# Access Compliance Report

## Public Rights-of-Way

### (Curb Ramps)

Intersection ID: 3528	Main Street: MALLARD_CREEK_RD	Cross Street: SAWGRASS_RIDGE_PL	Location: SW
ADA ID: 03E648A3BA55	Ramp Type: Perp	Initial Pass/Fail: Fail	Overall Compliance: No
Severity Score: 10			
Codes/Mitigation Info/Possible Solution		Field Measurements/Component Compliance

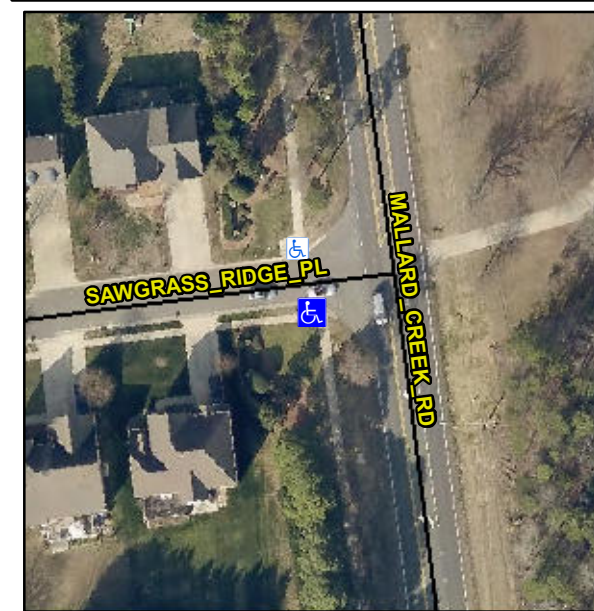
**R304.5.1, R304.5.3**

Compliance	Description	Data	Compliance	Description	Data
N/A	Ramp Length (in)	48.0	Yes	Ramp Slope (%)	6.5
No	Ramp Width (in)	42.0	No	Ramp XSlope (%)	4.8
N/A	Flare Type LT	N/A	N/A	Flare Type RT	N/A
N/A	Flare Slope LT (%)	N/A	N/A	Flare Slope RT (%)	N/A
N/A	Flare Traversable LT?	N/A	N/A	Flare Traversable RT?	N/A
N/A	Landing Length (in)	N/A	N/A	DWS Provided?	N/A
N/A	Landing Width (in)	N/A	N/A	DWS Contrast?	N/A
N/A	Landing Slope (%)	N/A	N/A	DWS Length (in)	N/A
N/A	Landing X Slope (%)	N/A	N/A	DWS Full Width?	N/A
N/A	Landing Curb? (Y/N)	N/A	N/A	DWS Offset (in)	N/A
N/A	Shared Landing?	N/A			
N/A	Gutter Ponding?	N/A	N/A	Gutter Slope (%)	N/A
N/A	Gutter Lip Ht (in)	N/A	N/A	Gutter X Slope (%)	N/A
N/A	Painted X Walk1?	No	N/A	Painted X Walk2?	N/A
	X Walk 1 Direction	To N		X Walk 2 Direction	N/A
N/A	X Walk 1 Width (in)	N/A	N/A	X Walk 2 Width (in)	N/A
	X Walk 1 Slope (%)	2.2		X Walk 2 Slope (%)	N/A
	X Walk 1 X Slope (%)	5.9		X Walk 2 X Slope (%)	N/A

**Remove & Replace Entire Ramp.**
